RAI 02.04.04-9, Supplement 1, Part A:

The following changes will be made to COLA, Part 2, Tier 1, Section 5.0, Tier 2 Subsections 2.0, 2.4S.1, 2.4S.2, 2.4S.4, 2.4S.6, 2.4S.10, 2.4S.14, 2.5S.5, 3.4, and 3H, and COLA Part 7, Subsection 2.1, to incorporate the revised main cooling reservoir (MCR) embankment breach analysis as described in the responses to RAI questions 02.04.04-9 and 02.04.04-10.

Supplement 1, Part B, to RAI 02.04.04-9 Response:

Figure 2.5S.4-23 Undrained Shear Strength (s_u) From CPT Data (STP 3)

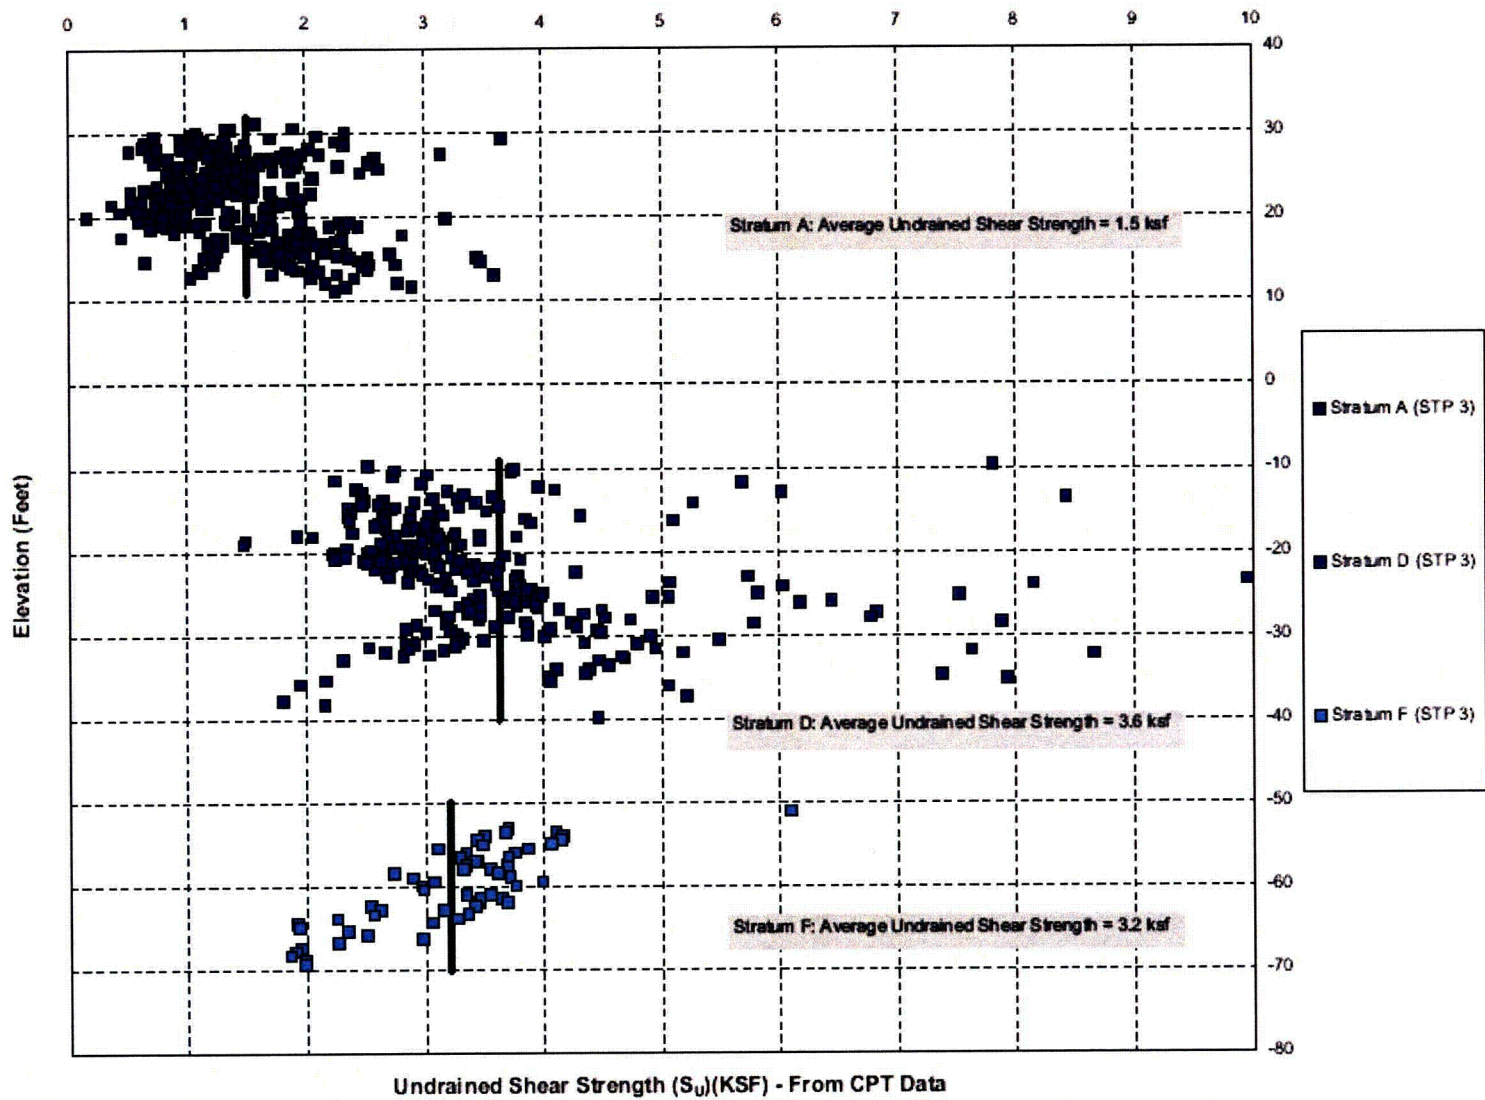
Shear strength values calculated in this way from the CPT data indicated an average $s_u = 1.51.7$ ksf. The CPT-derived values are shown versus elevation on Figure 2.5S.4-23, 2.5S.4-24, 2.5S.4-25, 2.5S.4-26, and 2.5S.4-27 for the STP 3 area, the STP 4 area, the area west of the Power Block, the area outside the Power Block, and site-wide, respectively. Note that SPT correlations were based on 1099-1235 field measurements, while CPT correlations were based on 862-1584 field measurements made on cohesive soil behavior types within Stratum A. The results of 1112 laboratory unconsolidated undrained (UU) triaxial strength tests and unconfined compression (UNC) strength tests on selected samples indicated an average $s_u = 1.31.4$ ksf. Laboratory shear strength test results are summarized in Table 2.5S.4-9 and plotted versus elevation on Figure 2.5S.4-22. UU strength results from the STP 1 & 2 UFSAR (Reference 2.5S.4-3) indicated $s_u = 0.9$ ksf for the upper portion of Stratum A (i.e., Stratum A₁) and $s_u = 2.3$ ksf for the lower portion of Stratum A (i.e., Stratum A₂), and were comparable to the results of this subsurface investigation. Based on the results of this subsurface investigation, an undrained shear strength of $s_u = 1.61.5$ ksf was selected for Stratum A, averaged from the SPT (N_{60})- N_{60} -value correlations, the CPT correlations, and the laboratory testing results.
